**MINUTES  
CITY OF LAKEWOOD  
BOARD OF BUILDING STANDARDS/  
ARCHITECTURAL BOARD OF REVIEW/SIGN REVIEW**

**REVIEW MEETING  
MARCH 11, 2021 at 5:30 P.M.  
LAKEWOOD CITY HALL  
VIRTUAL MEETING**

**Docket No. 03-14-20 12600/12508 Berea Road  
Site Improvements and Fence Modifications - March 2021**

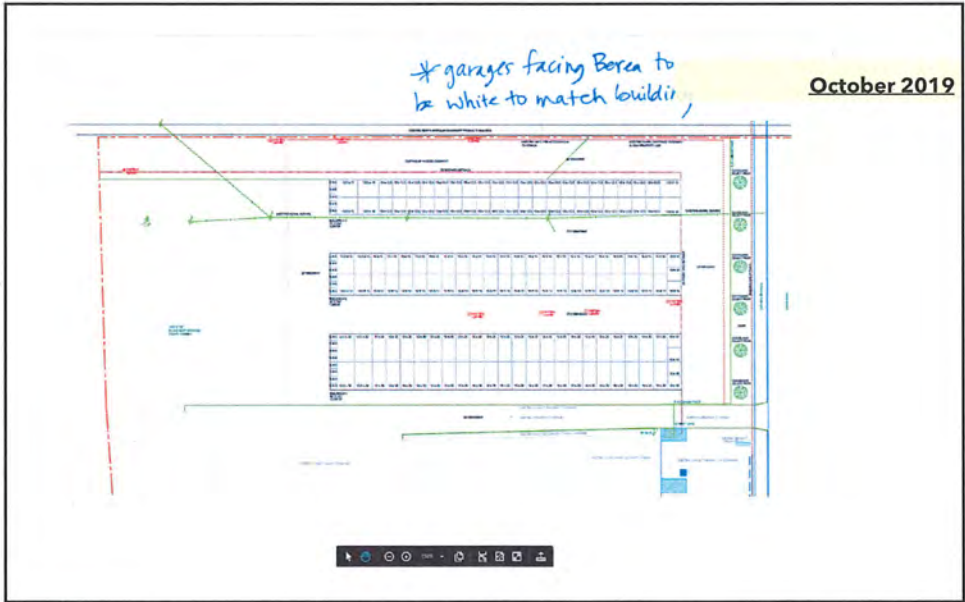
Staff provided an overview of the project. Melissa Reynolds, Rolan Brothers Fence and Jim Jakubus, Construction Manager, Pagoda Companies were present to explain the request. The members asked about signage, access to the property, installation of a curb for the permeable pavers, stormwater run-off. There were no comments from staff. Public comment was closed as no one addressed the project. There were no e-mails or chats.

A motion was made by Mr. Donaldson, seconded by Mr. Waddell to **APPROVE** the request with the following conditions:

- Signage shall be provided at gate to state "No Public Entry".
- Concrete curb to be provided to hold permeable pavers at edge (graphic provided).

**Docket No.: 03-15-21 1183 Cook**  
**Front Porch - March 2021**

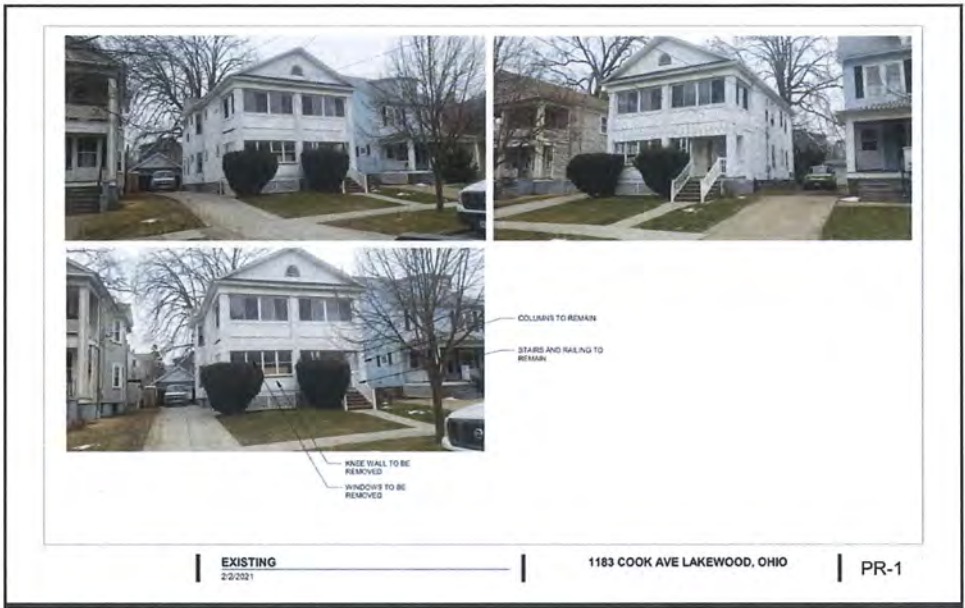
Carly Shenigo, applicant was present to explain the request. the members said it was a nice addition to the home. The asked about the piers, awning detail, and base of the house. Staff asked for confirmation of the front door selection and liked the opening of the porch. Public comment was closed as no one addressed the project. There were no chats or e-mails.

A motion was made by Mr. Donaldson, seconded by Mr. Grambort to **APPROVE** the request with the following conditions:

- Door to be provided as marked on submittal (half lite at door and at side panels).
- Vinyl soffit to be provided on underside of new overhang.
- Treatment of piers to match base of house.

**Docket No.: 03-16-21 1553 Rockway  
Porch - March 2021**

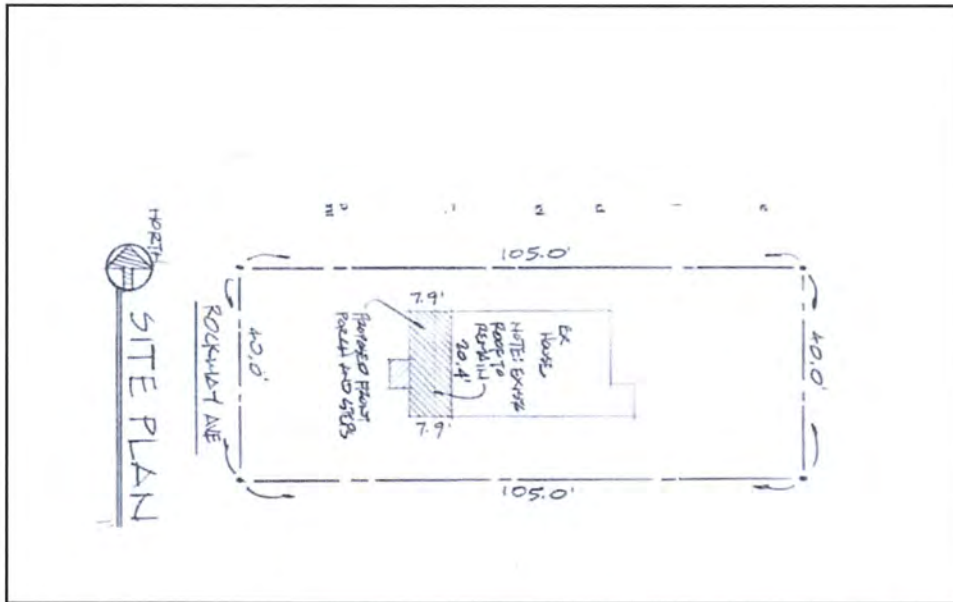
Staff provided a brief summary of the project. David Borowske, Borowske Builders Inc. was present to explain the request. The members told the applicant to pay attention to the columns detail, and they liked the proposal. Public comment was closed as no one addressed the project. There were no chats or e-mails.

A motion was made by Mr. Donaldson, seconded by Mr. Waddell to **APPROVE** the request with the following condition:

- Provide base trim at columns.
